### **AMENDMENTS TO THE DRAWINGS:**

Responsive to the Examiner's request for clarification, Applicants propose amending drawing Figures 1, 2, 3, 5 and 6, as set forth below.

### **REMARKS/ARGUMENT**

FIG. 1

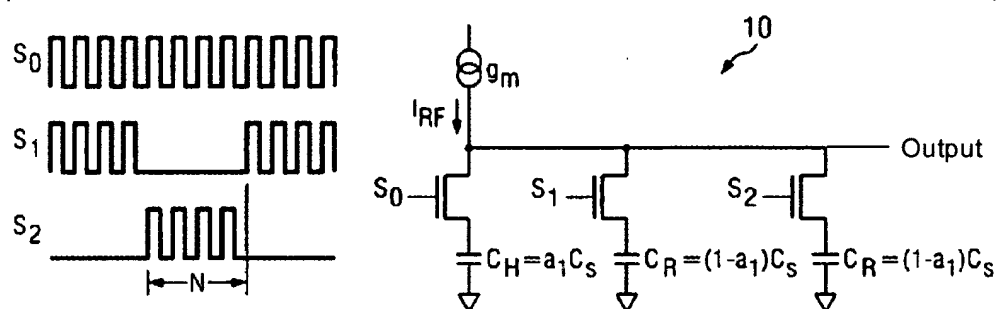
Regarding Figure 1, Applicants propose adding the identifier "Output" and a lead line to the source of transistor S<sub>2</sub>. Support for the amendment and is enabled by the specification and derived from US 2003/0035499 A1.

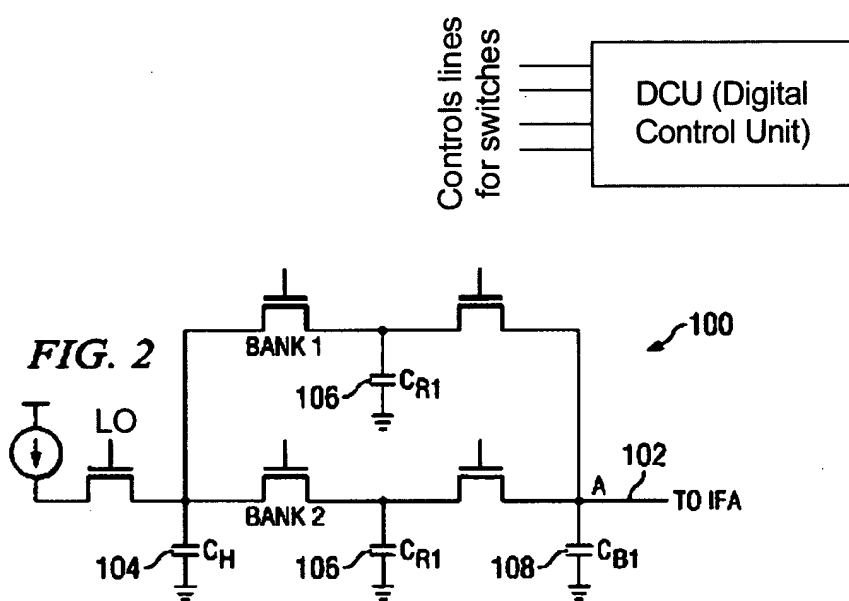
Regarding Figure 2, Applicants propose adding the identifier "LO" to the gate of the transistor below "FIG. 2". Applicants also propose adding a DCU (Digital Control Unit) that outputs control lines for the switches. Support for the amendment is shown in Figure 4A which shows the DCU. The timed operation of switches to combine and split capacitors is described in the specification. LO is shown in Figure 4A and in US 2003/0034499 A1, which is incorporated by reference.

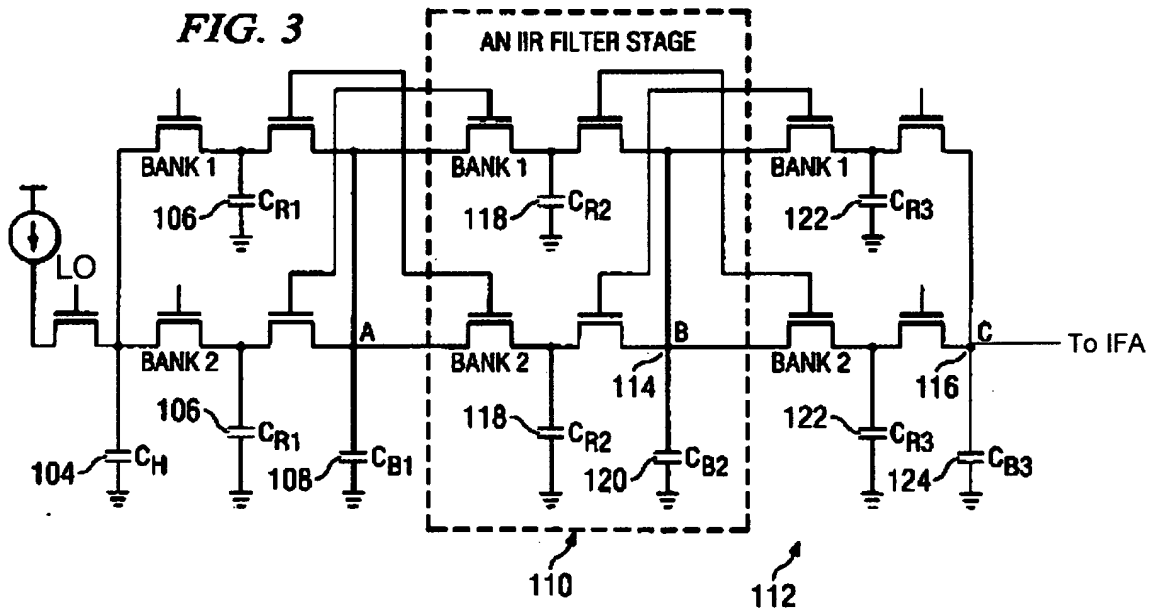
Regarding Figure 3, Applicants propose adding the identifier "LO" to the gate of the transistor just to the left of the identified "BANK 2". Applicants also propose adding an identifier "TO IFA" and a lead line from the identified to node "C". Applicants further propose adding a DCU (Digital Control Unit) that outputs control lines for the switches. Support for the amendment is shown in Figure 4A which shows the DCU. The timed operation of switches to combine and split capacitors is described in the specification. LO is shown in Figure 4A and in US 2003/0034499 A1, which is incorporated by reference. The output connected to IFA input is described on page 6: line 16 in the specification.

**FIG. 5**

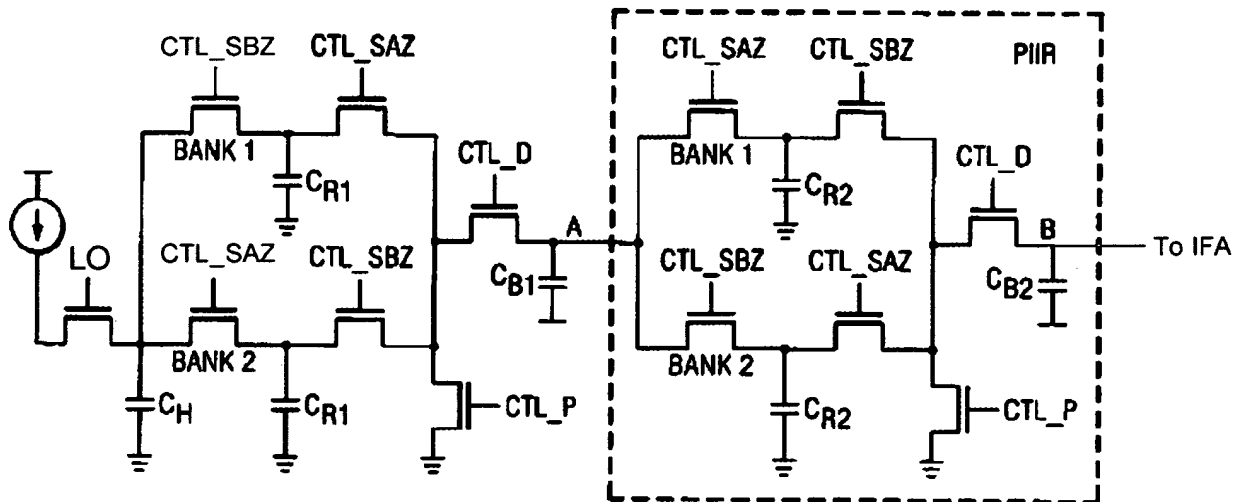
Regarding Figure 5, Applicants propose adding the identifier "LO" to the gate of the transistor just to the left of the identified "BANK 2". Applicants also propose adding the identified "CTL\_SAZ" to the gate of the transistor just above the identified "BANK 2". Applicants further propose adding the identifier "CTL\_SBZ" to the gate of the transistor

just above the identifier "BANK 1". Applicants yet further propose adding an identifier "TO IFA" and a lead line from the identified to node "B". Applicants also propose adding a "Clock Generation" box with identified output signals CTL\_SAZ, CTL\_SBZ, CTL\_D, and CTL\_P. The timed operation of switches to combine and split capacitors is described in the specification on page 6, lines 17-29. LO is shown in Figure 4A and in US 2003/0034499 A1, which is incorporated by reference. The output connected to IFA input is shown also in Figure 4B.
